Golder Associates Inc.

May 21, 2008

**RE: BUCKEYE FLORIDA, LIMITED PARTNERSHIP
AIR PERMIT APPLICATION NO. 1230001-023-AC/PSD-FL-397
MODIFICATION TO THE NOS. 1 AND 2 POWER BOILERS, NOS. 1 AND 2 BARK
BOILERS, NOS. 2 AND 3 RECOVERY BOILERS, AND PULPING SYSTEM
REQUEST FOR ADDITIONAL INFORMATION NO. 2**

Buckeye Florida, Limited Partnership (Buckeye) has received the Department's (FDEP's) request for additional information (RAI) dated May 1, 2008, regarding the Foley Energy Independence Project. Each of the Department's requests is answered below, in the same order as they appear in the RAI letter.

Figure 2-10
 No. 3 Recovery Boiler: After Low Odor Conversion Flow Diagram
 Buckeye Florida, L.P.

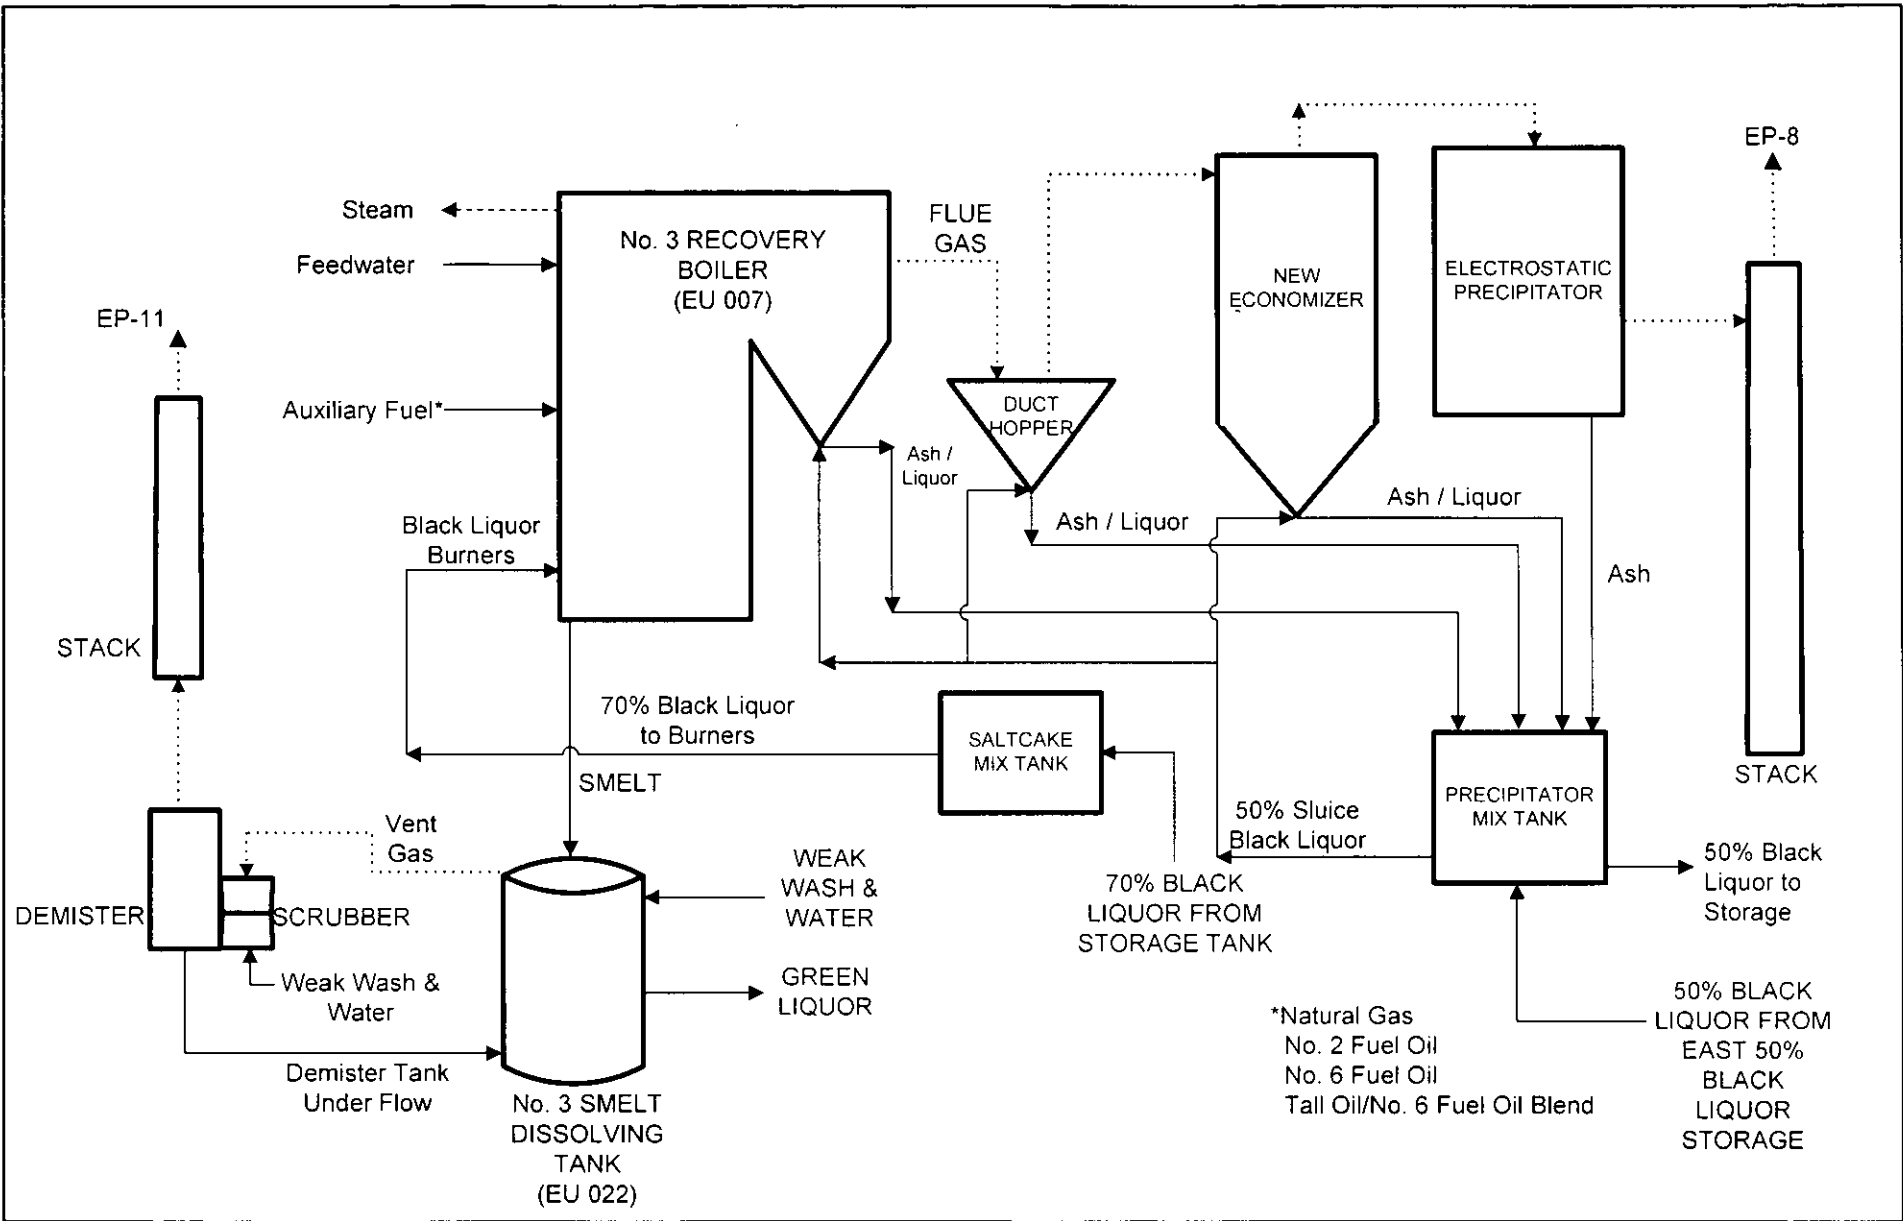
Comment 1. As previously requested, please provide the details of the work to be performed on the Nos. 2 and 3 Recovery Boilers that will convert each unit to the Non-Direct Contact Evaporator design (ductwork, economizers, tubing, refractory, etc.)

Ash collection & mix tanks – An ash collection system will be installed to collect the ash from the new economizer and flue gas ducts and mix the ash into the black liquor. The system on this boiler will be a sluice system where black liquor is pumped from the existing precipitator mix tank to sluice bowls located on the economizer and flue gas duct hopper outlets. Ash will mix with the black liquor in the sluice bowls and will return by gravity to the precipitator mix tank. A revised flow diagram of the proposed No. 3 Recovery Boiler, including the proposed ash sluice system, is provided in Figure 2-10 of Attachment A of this response.
